Project note

To	Anna Gallagher
	Tetra Tech Coffey
From	Malcolm McCausland
	m +61 458 902 838
	e malcolm.mccausland@entura.com.au
Project	Response to TPC RFI for RemNWTD design change ECOVAR31
Project reference	E30979-P514276
Document number	HTE006-1198835273-1593
Subject	Response to TPC RFI for RemNWTD design change

Revision 1.1			
Revision description	ECOVAR31 deliverable to provide response to TPC RFI for the RemNWTD design change including replacing 25 towers with dual monopoles on the Sheffield to Burnie section of the alignment and increasing the height of two towers on the Heybridge Spurs.		
Prepared by	Rachael Wheeler and Carley Fuller		15 Dec 2025
Reviewed by	Raymond Brereton		15 Dec 2025
Approved by	Malcolm McCausland		15 Dec 2025
	(name)	(signature)	(date)
Distributed to	Anna Gallagher	Tetra Tech Coffey	17 Dec 2025
	(name)	(organisation)	(date)

Figure 2.1: Map of RemNWTD and proposed design changes

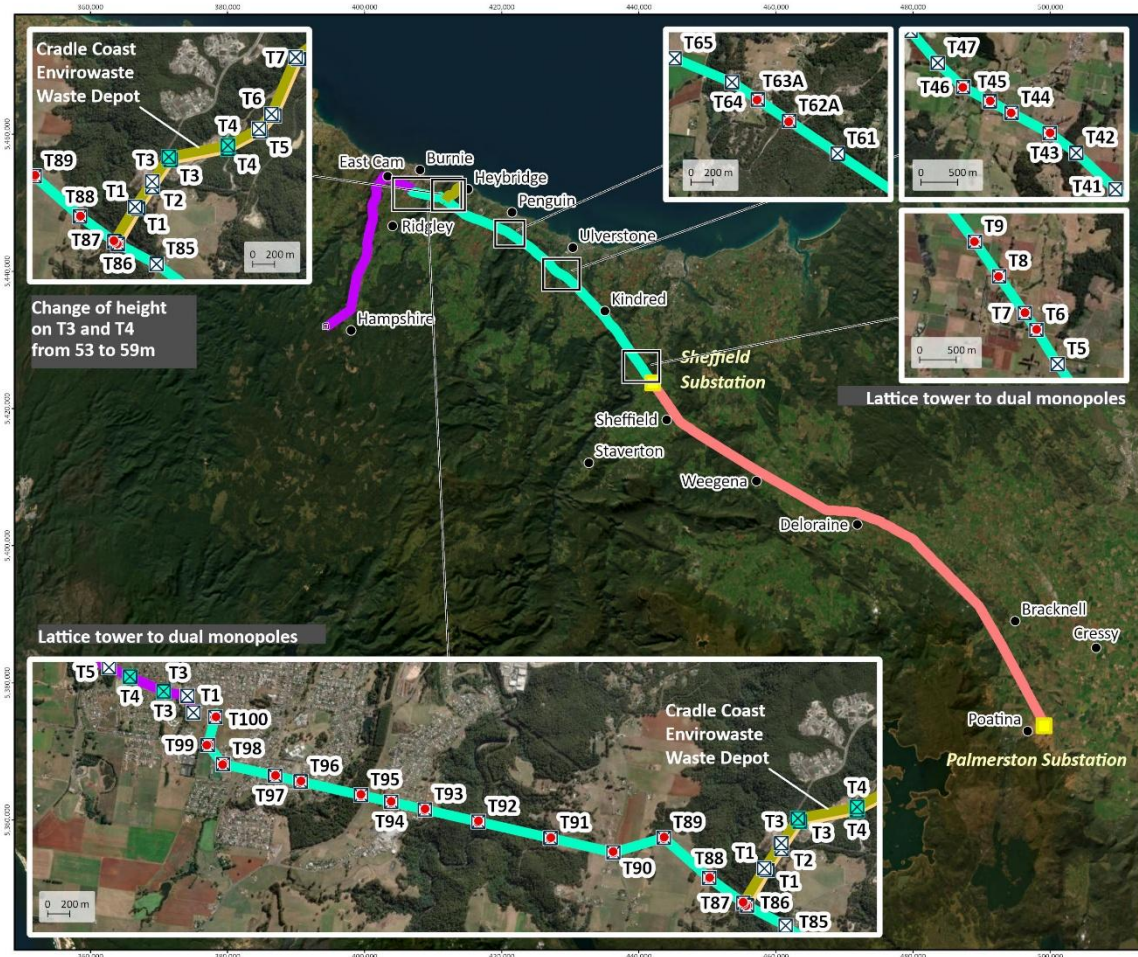
- the replacement of 25 steel lattice towers with dual monopoles (i.e. 50 poles) on the SH-BU section in constrained locations, which is necessary to minimise significant outages and their associated impacts. Specifically, this Project amendment will prevent the need of a single three-month outage and instead result in a series of 'day' outages, as the poles will enable the existing 220 kV OHTL to remain in situ during construction allowing it to be energised outside of construction hours.

- increasing the height of two towers (T3 and T4) on the HBSpurs section. The nominated maximum height of towers for the HBSpurs was originally 53 m, because HBSpurs is the only greenfield section of stage one of RemNWTd. TasNetworks proposes to increase the nominated maximum height of these two towers to 59 m such that the Cradle Coast Envirowaste Waste Depot ('the landfill') can be safely spanned by the transmission line. The increase of 6 m is required to accommodate a potential increase in height of the landfill surface if the waste depot operations are intensified.

- for the dual monopole design, the minimum vertical distance between phases on the same pole is 6 m, and the minimum horizontal separation between the circuits is 13 m.

- each pole of the dual monopole structure will carry one 220 kV circuit and will have its own separate foundation.
- an area of approximately 30 m by 30 m will be required to construct each transmission dual monopole structure, and that this construction pad will be located within the 80 x 50 m tower workspace area assessed previously.

- there will be no changes to vegetation clearance requirements.
- the 8.5 m by 8.5 m is the total operational footprint area of the two poles combined, and it will be located within the 15 m by 15 m operational footprint proposed for the original towers.

- pole centre spacing between the poles will be approximately 13 m for Light Suspension and 16 m for Heavy Strain dual monopole structures.
- pole heights will change as shown in Table 2.1.

Figure 5.1: Tasmanian eagle nests within 1 km of the SH-BU and HBSpurs sections of the RemNWTD Project

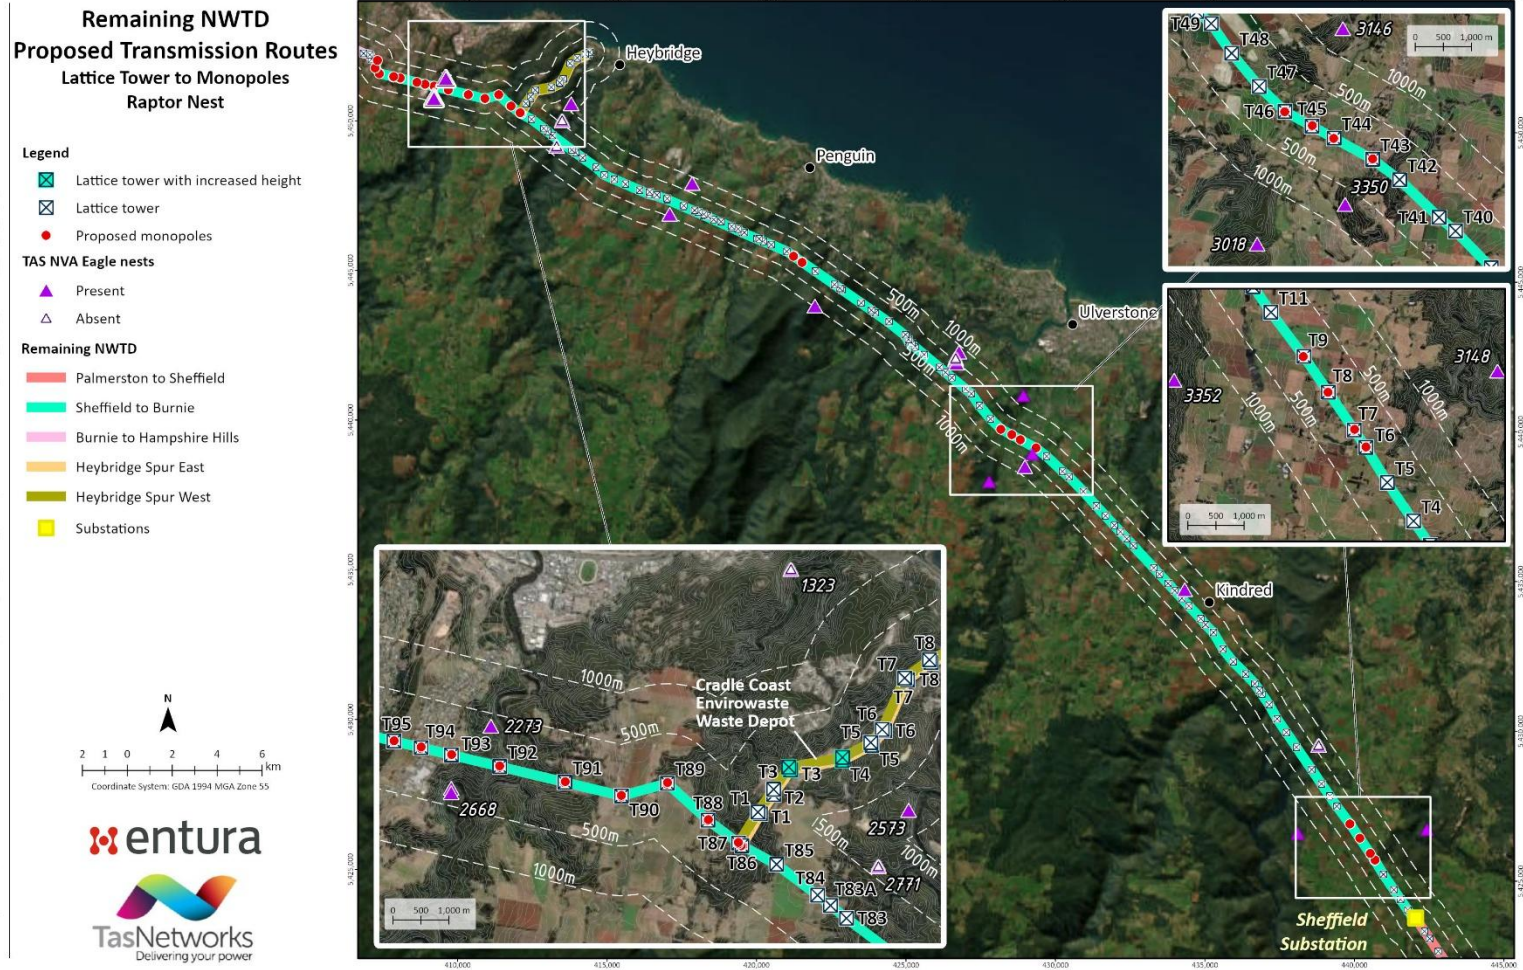
Of these, there are three Tasmanian wedge-tailed eagle nests within 1 km of the proposed dual monopoles (Figure 5.1), including:

- Nest #2273² last recorded in October 2024 and is located within 1 km from dual monopoles T91A and T91B; T94A and T94B; and T95A and T95B. Note this nest is also within 500 m of dual monopoles T92A and T92B; and T93A and T93B thus may still be impacted by the RemNWTD project.
- Nest #2668 last recorded in October 2024 and is located within 1 km of T92A and T92B; T94A and T94B; and T95A and T95B. Note this nest is also within 500 m of dual monopoles T93A and T93B thus may still be impacted by the RemNWTD project.

- Nest #3350 last recorded in March 2024 and is located within 1 km of T43A and T43B, and T44A and T44B.

The poles will have varying heights (33 m to 60 m) that differ from the heights proposed for the previous tower design (Table 2.1). The proposed pole heights for T43A and T43B are 0.8 m shorter than the previous tower design, and for T44A and T44B are 2.7 m higher than the previous tower design. Nest #3350 was identified as being within 1 km line-of-sight excluding extant vegetation for the originally proposed towers T43 and T44. The topography in the area suggests this nest is unlikely to fall out of line-of-sight from the shorter T43A and T43B poles (Figure 5.1), however viewshed analyses have not been undertaken on this nest (refer section 3). Nonetheless, the nest was within 1 km line-of-sight from the tower T44, thus the increase in pole height for the replacement dual monopoles will not change the potential impact on this nest. However, the impact to Tasmanian eagles from the changes in pole heights relative to the previous tower design remains unchanged.

Figure 7.1: Cumulative electric field (kV/m) from the new 220 kV transmission line 13.3 m from the ground and the existing 110 kV line 6.7 m from the ground, during typical operation. Source: Jacobs, 2025

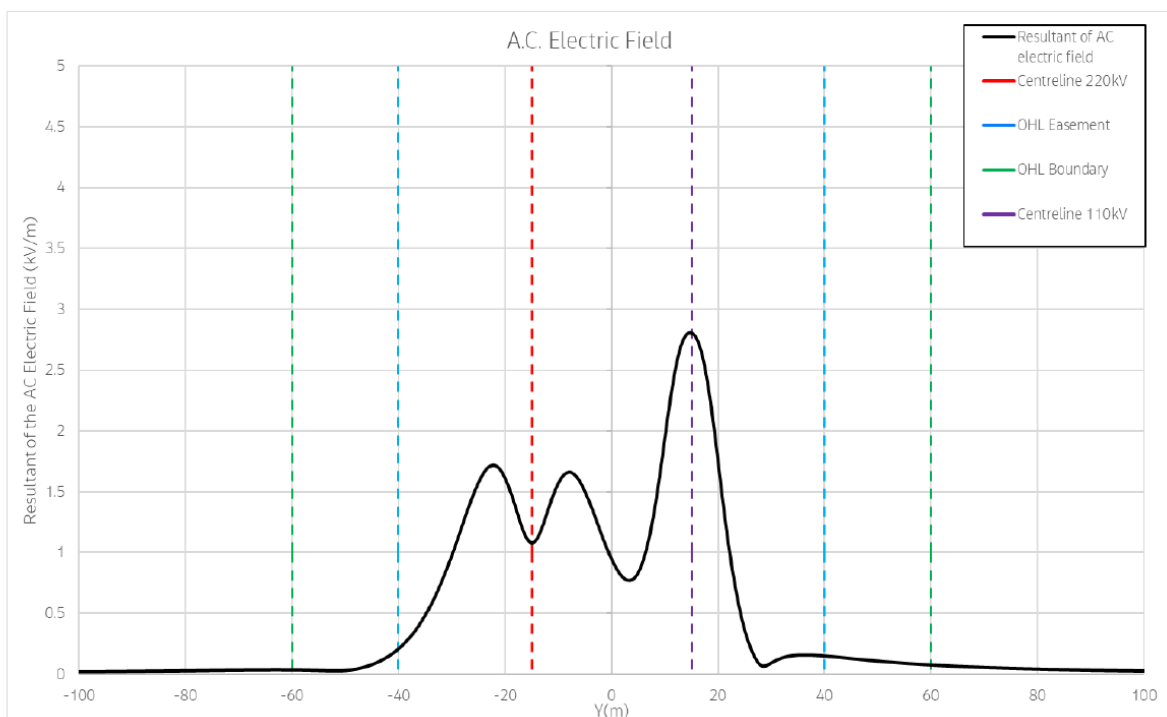
However, the precautionary principle suggests that it should be assumed that if the Project will introduce new EMF within 100 m of platypus-suitable waterways traversed by easement, the EMF experienced by resident platypuses may be elevated to a degree that could interfere with their electroreception and thus hunting success. The *Remaining North West Transmission Developments EMF, Audible Noise and Radio Frequency Interference Assessment* by Jacobs (2025), determined that the typical operations' cumulative EMF of the proposed new 220 kV OHTLs and the adjacent, existing 110 kV OHTLs, may be up to 2.7 kV per metre (Figure 7.1).

The strength of the EMF is proportional to the amount of electrical current passing through the power line and decreases as distance increases. Specifically, the strength of the EMF waves radiating from a transmission line is inversely proportional to the square of the distance of the receptor (e.g. a platypus) from the source. Because of this property, the EMF exposure that a platypus would receive from a power line would decrease where tower heights are raised and would increase where tower heights are lowered (refer Table 2.1).

Figure A.11: Proposed dual monopoles to replace SH-BU T86 at the HBSpurs tee-off located in native vegetation *Eucalyptus obliqua* dry forest

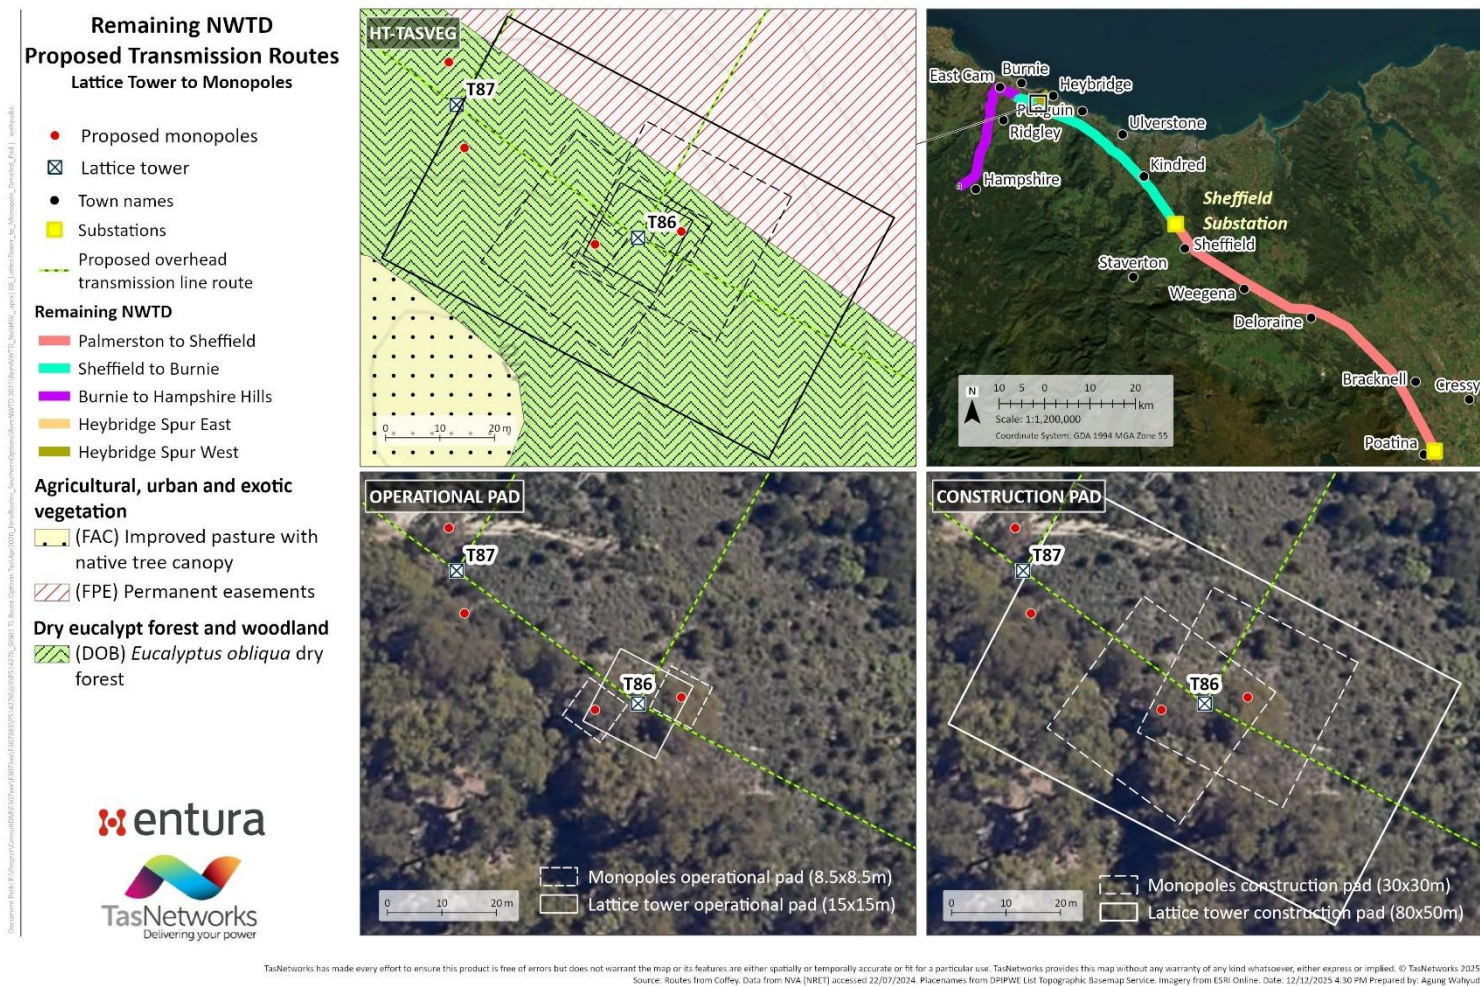
Two of the 25 towers (towers T86 and T87) proposed to be replaced by dual monopoles fall within *Eucalyptus obliqua* dry forest at the tee-off for the HBSpurs (Figure A.11 and Figure A.12); thus, the area of permanent native vegetation clearance required for the operational footprint of the four poles in the revised design will be less than that required for the two towers in the preliminary design (0.3 ha as compared with 0.4 ha). The remainder of the proposed dual monopoles are situated in modified vegetation communities including agricultural land or permanent easement.

No threatened flora species have been recorded in this area of native vegetation (on the NVA nor during ecological field surveys to date) where the four dual monopoles are to replace towers T86 and T87; therefore, the impact on threatened flora species from the revised Project design remains unchanged.
